SUNDRY NOTICES AND REPORTS ON WELLS (DO NOT USE THIS FORM FOR PROPOSALS TO DRILL OR TO DEEPEN OR PLUG BACK TO A DIFFERENT RESERVOIR. USE "APPLICATION FOR PERMIT" (FORM C-101) FOR SUCH PROPOSALS.)	
1. Type of Well: Oil Well <input checked="" type="checkbox"/> Gas Well <input type="checkbox"/> Other <input type="checkbox"/>	5. Indicate Type of Lease STATE <input type="checkbox"/> FEE <input checked="" type="checkbox"/>
2. Name of Operator Armstrong Energy Corporation	6. State Oil & Gas Lease No.
3. Address of Operator PO Box 1973, Roswell, NM 88202	7. Lease Name or Unit Agreement Name SV Chipshot
4. Well Location Unit Letter <u>K</u> : <u>2164</u> feet from the <u>South</u> line and <u>1362</u> feet from the <u>West</u> line Section <u>11</u> Township <u>16S</u> Range <u>36E</u> NMPM Lea County	8. Well Number <u>1</u>
11. Elevation (Show whether DR, RKB, RT, GR, etc.) 3886' GR

SV Chipshot #1

API Number 30-025-33466

Proposed Plugging Procedure

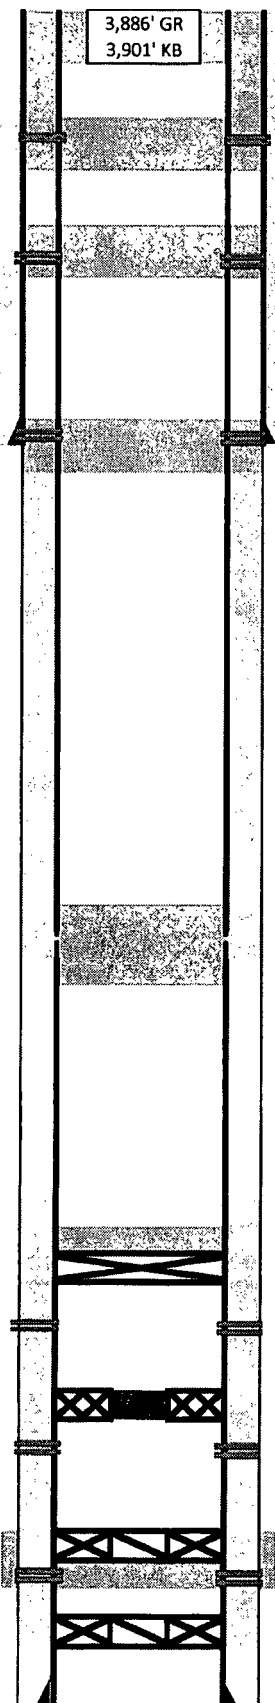
P+S 50 5x 3300 base of salt
